APPLICATION NO.	FILING DATE	FIRST NAMED INVENTOR	ATTORNEY DOCKET NO.	CONFIRMATION NO.
10/633,958	08/04/2003	Hye Suk Chi	RPS920030032US1	5183

Office Action Summary

DETAILED ACTION

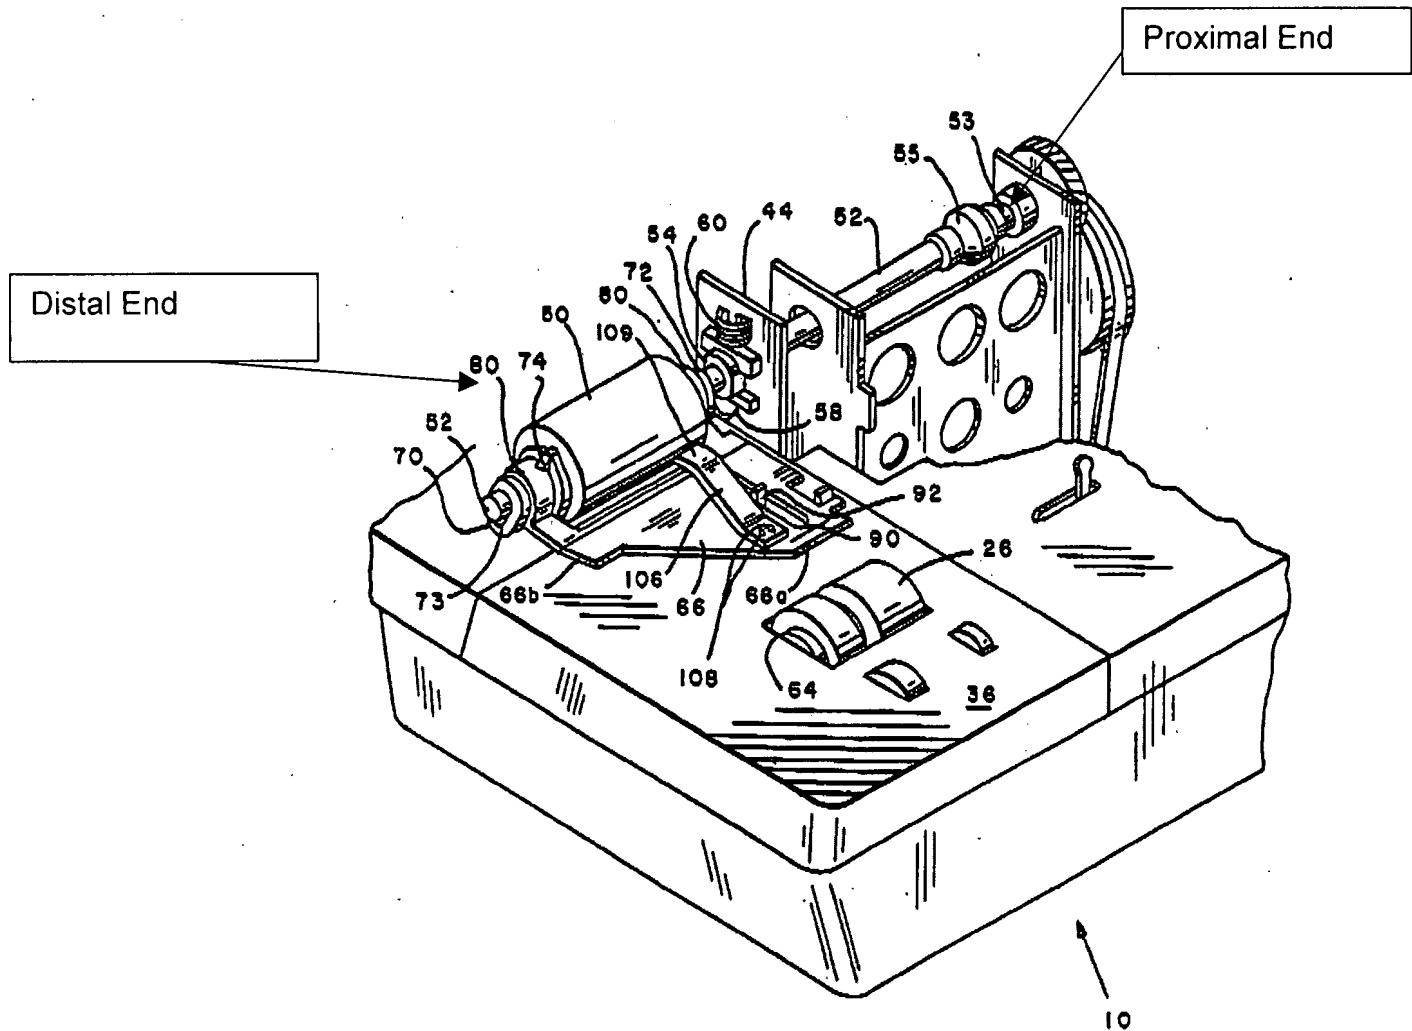
Claims 1-3, 9-15, 18-26 and 29-47 are rejected under 35 U.S.C. 102(b) as being anticipated by Miciukiewicz (US Patent 4,763,575).

Regarding claims 1,10,20,32-33, 40, 41, 46 and 47, Miciukiewicz teaches a method and apparatus comprising a frame (10, 12), at least one cantilevered roller shaft (52) comprises a distal end and a proximal end (refer to figure on page 3) for advancing a document (18), wherein the proximal end is coupled to the frame of such that the distal end floats (As for advancing a document, wherein the at least one cantilevered roller shaft is supported only at one end (Figure 2), a bushing/bushings (70, 72) coupled to the at least one cantilevered roller shaft and a spring (106) coupled to the frame and the bushings via a pressure plate (66) and attached at portion 109.

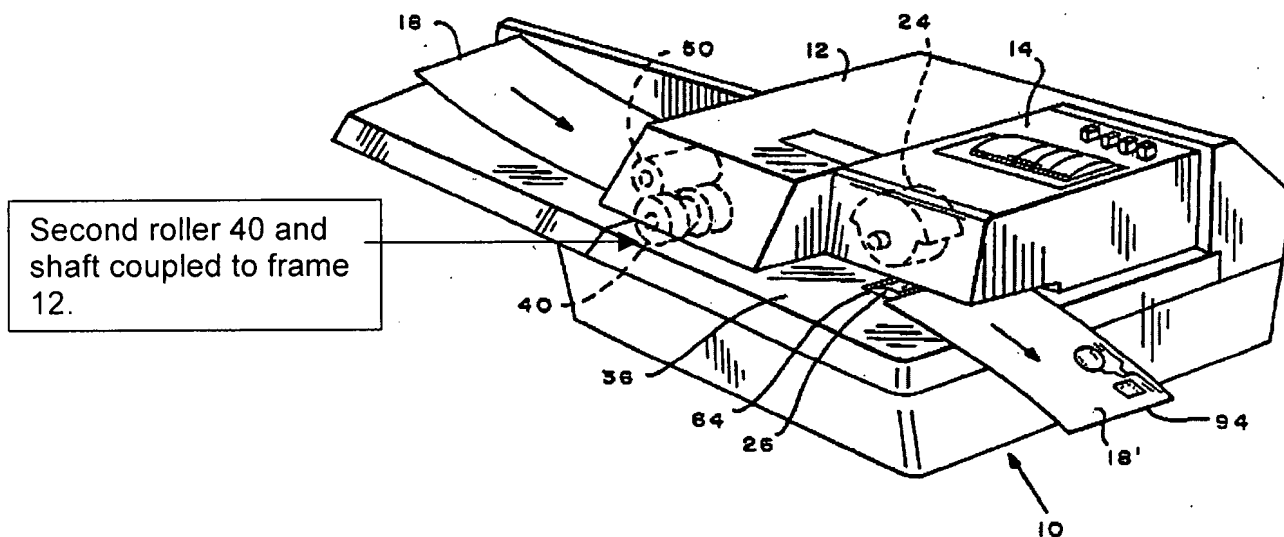
supported at two support locations (44, 55) located outside a document path, wherein the document (18) can be appropriately fed and wherein the need for a rigid frame directly supports the unsupported end is eliminated (Figure 2).

**FIG. 1**

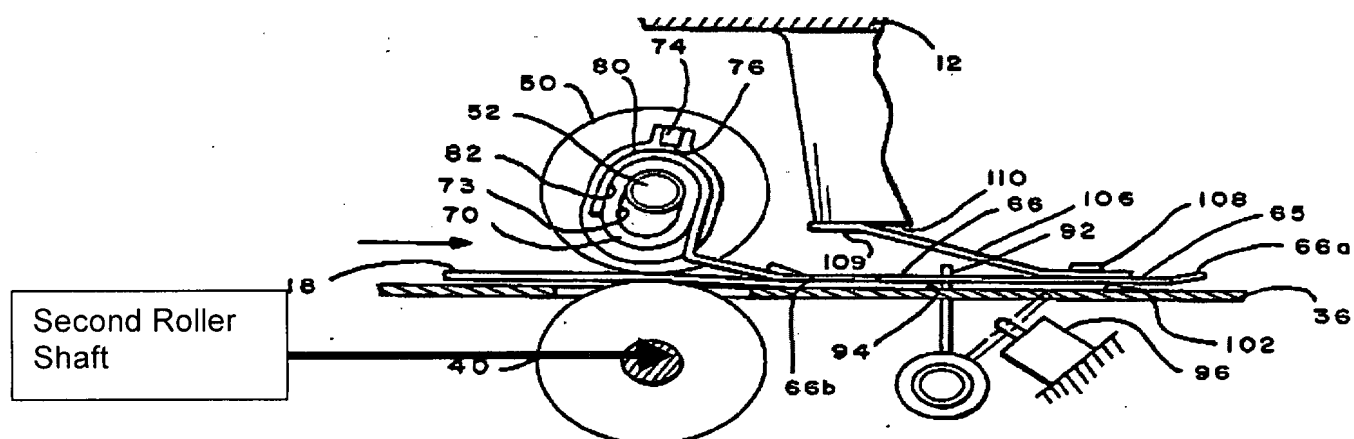
Regarding claim 15, 26, 34-36, 38, 39, 42 and 43, Miciukiewicz teaches a method and apparatus comprising, a second roller shaft coupled to the frame (refer to figure 4 on page 5 and figure 1 below) for advancing a document, a second roller shaft having a distal and proximal end (refer to figure 8 on page 5), wherein the distal end floats and wherein the document is removed from the path (inherent feature).

Regarding claims 18, 29, 44 and 45, Micrukiewicz teaches a method and apparatus comprising wherein the frame further comprises a main portion (12) and front portion (10), and wherein the second roller shaft (refer to figure 1 on page 4 and figure 4 on page 5) is coupled to the main portion such that the second roller shaft does not rely on the front portion for support.

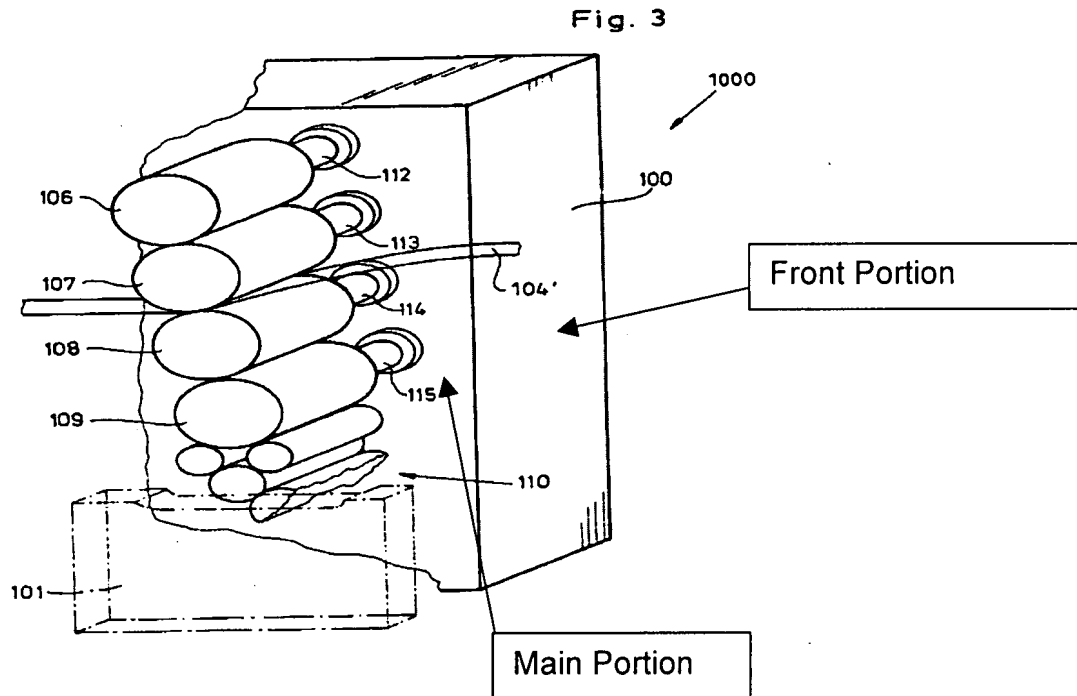
Regarding claims 1,10,20,32-34,40-42, 46 and 47, Guaraldi teaches an apparatus and method comprising a frame (100), at least one cantilevered roller shaft

(113) comprises a distal end and a proximal end for advancing a document (104), wherein the proximal end is coupled to the frame of such that the distal end floats (As shown in Figure 3 and Column 6, Lines 14-36) and the at least one cantilevered roller shaft is supported only at one end (Figure 3) and a bearing (116). However, he does not explicitly disclose a spring coupled to the frame and the bearing. Jeschke teaches a spring (23) connected to a bearing block (18) and frame.

Regarding claims 4, 13, 23, Guaraldi teaches a method and apparatus wherein a frame (100) further comprises a main portion and front portion (refer to figure 3 below), and wherein the at least one cantilevered roller shaft (113) is coupled to the main portion such that the at least one cantilevered roller shaft does not rely on the front portion for support (Figure 3).

Regarding claims 18, 29, 44 and 45, Guaraldi teaches a method and apparatus comprising wherein a frame (100) further comprises a main portion and front portion (refer to figure 3 on page 3 of the office action), and wherein the second roller shaft (114) is coupled to the main portion such that the second roller shaft does not rely on the front portion for support (Figure 3).
